PROJECT LOCATION:
63 OLD HILL ROAD WESTPORT, CT

PROJECT TITLE:
SITE IMPROVEMENTS FOR A PROPOSED PADDLE TENNIS COURT

DRAWING TITLE:
SITE DEVELOPMENT PLAN

C-1.0

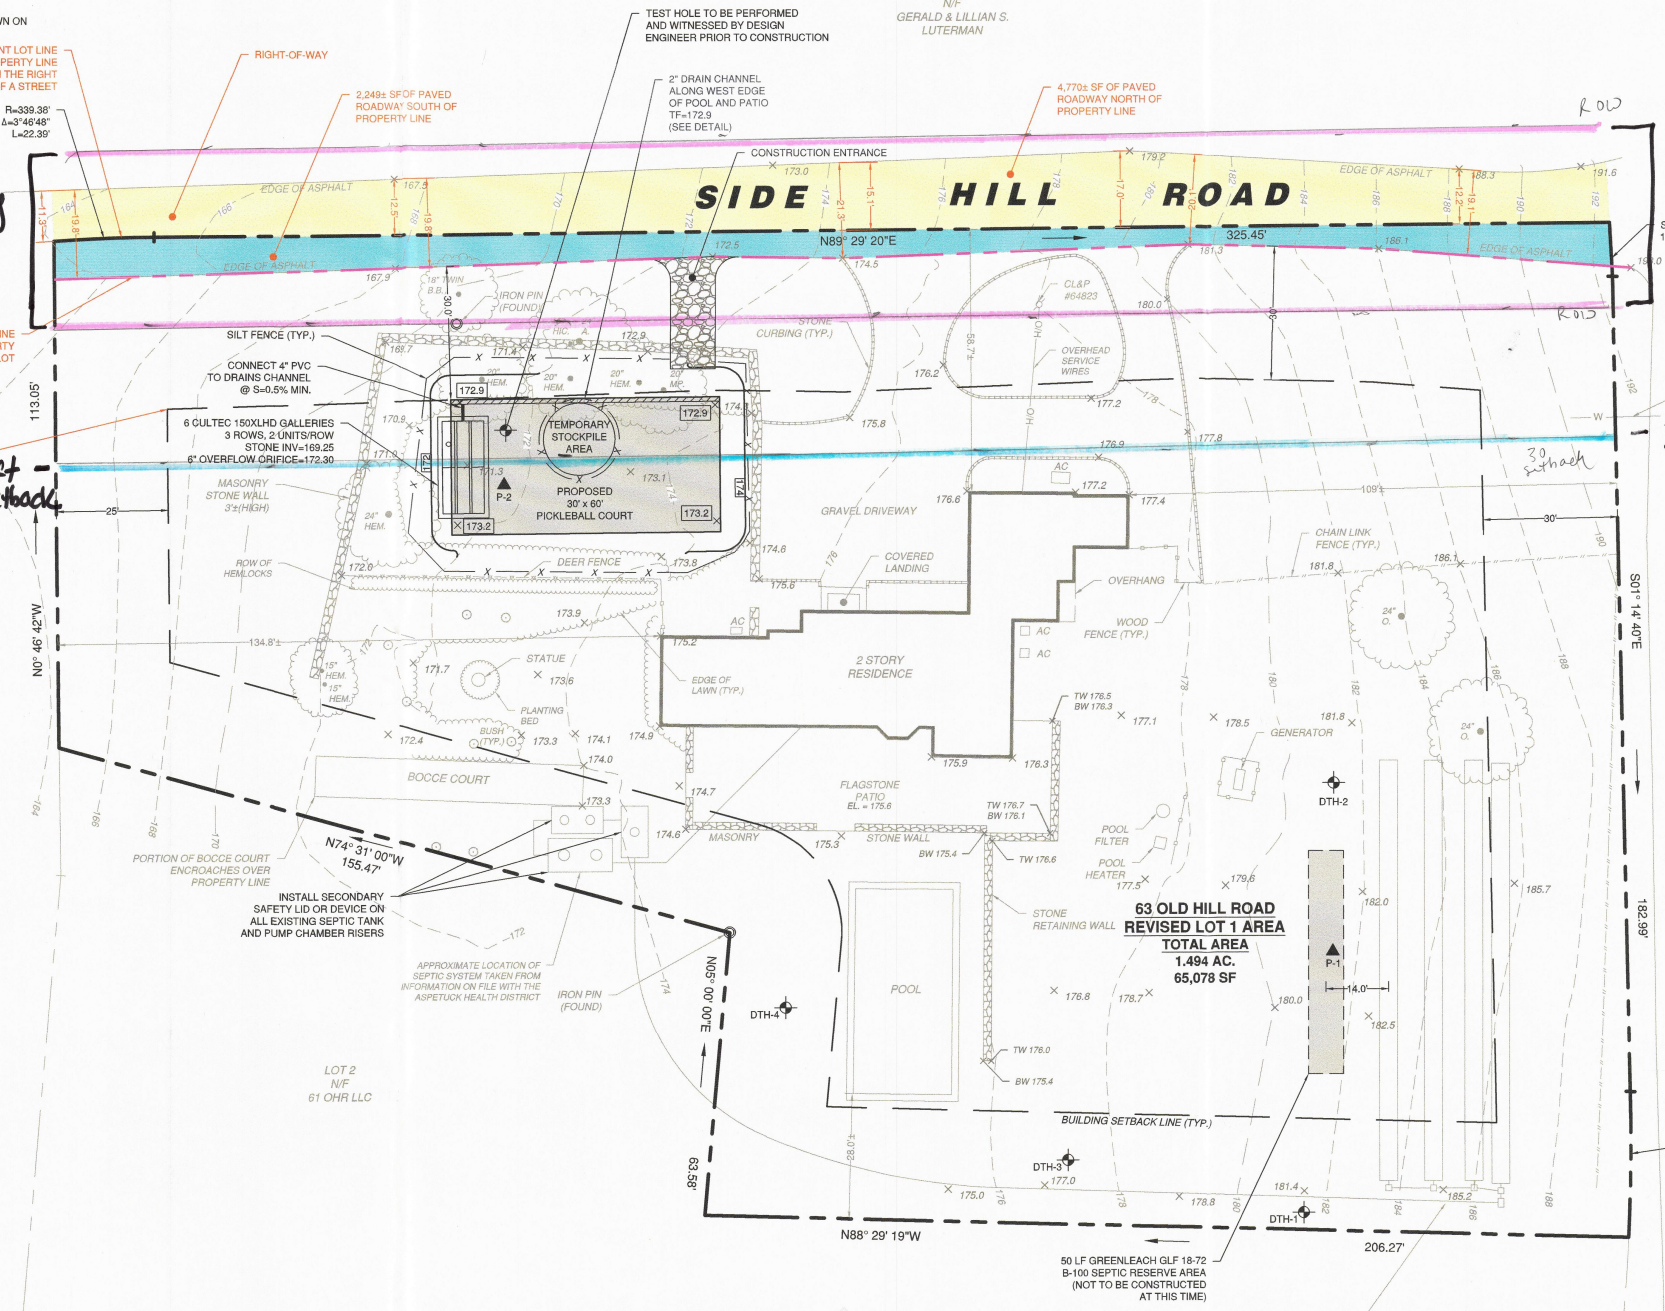
Right of way (40')

30 ft setback

Right of way 30 ft setback per staff

MP 9/3/24
